Docket Item # 5 BAR CASE # 2009-0273 and BAR Case #2008-0175

BAR Meeting December 9, 2009

ISSUE:	Addition/Alterations
APPLICANT:	Church of God and Saints of Christ, Sixteenth Tabernacle
LOCATION:	634 N. Patrick Street
ZONE:	RB/Residential

Figure 8: East and south elevation.

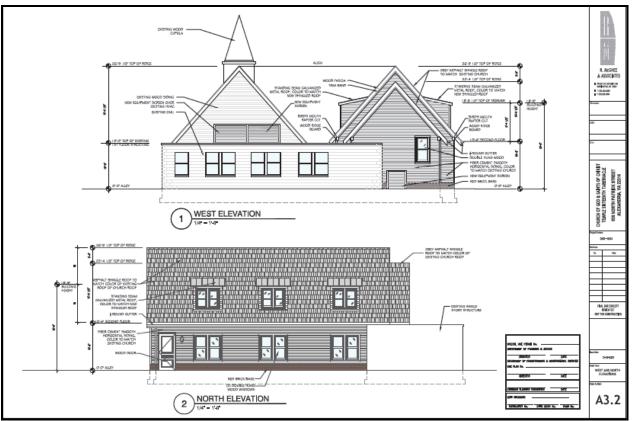
The east elevation will have four window openings on the first floor, two being paired in the middle, with single windows on either side. The second floor paired windows in the gable end will be in line with the first floor windows. The corners of the east elevation will have a one foot square recess. The east elevation of the existing one-story addition, which will connect the existing church with the new addition, will become a primary entrance to the church facility with the addition of a new wood double door. A skylight will also be installed in the roof of the one-story connection to provide light into the interior of this part of the building.

The south elevation will have the same window configuration as the north elevation, three pairs of windows on both the first and second floors. Two new doors will be incorporated into the south elevation of the church facility, one in the new addition for access to the fellowship hall, and the other into the existing one-story addition.

Staff objects to the use of two different roofing materials (asphalt shingles and standing seam metal) on the proposed addition. While there are certainly plenty of examples of both types of roofing materials in the historic district, they are seldom combined on a single building. The *Design Guidelines* specifically recommend "for new construction, materials should reflect contemporary design standards and be compatible with adjacent structures." Staff would argue

that it is incompatible to mix roofing materials and that both the dormers and the main gable roof should be the same material. While Staff would prefer that the roof of the addition be standing seam metal, it would also be acceptable for the roof to be asphalt shingle given the new construction. It is Staff's strong recommendation that when the historic church is in need of a new roof, that a historically appropriate roof material be used, such as standing seam metal or stamped metal shingles.

- 3. That all elements of the new addition, the gable roof and the dormers, be clad with the same roofing material, with a preference that the roof be clad in standing seam metal as proposed for the dormer roof;

Figure 9: North and west elevation.

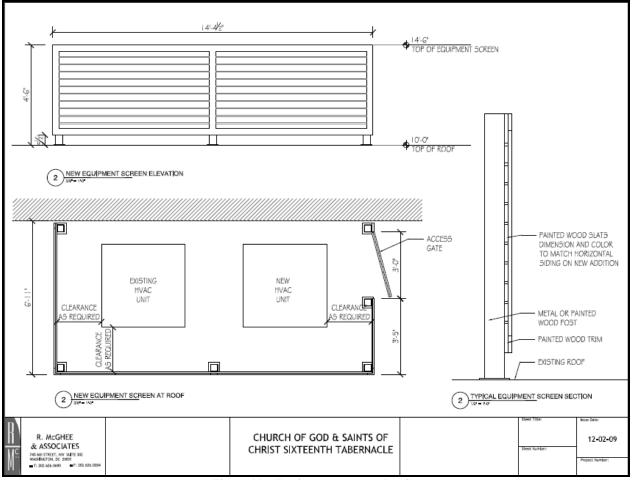
The north elevation of the proposed addition will contain three sets of double-hung, one-overone paired wood windows on the first floor, and paired windows within the three dormers on the second floor. A single door will also provide access into the new fellowship hall along this elevation. The new addition will be located 6 feet 3 inches away from the historic church to the north.

The west elevation of the addition will tie into the existing addition at the north east corner and will contain a single double-hung window. This elevation will have a double gable with the smaller gable encompassing the stair to the second floor.
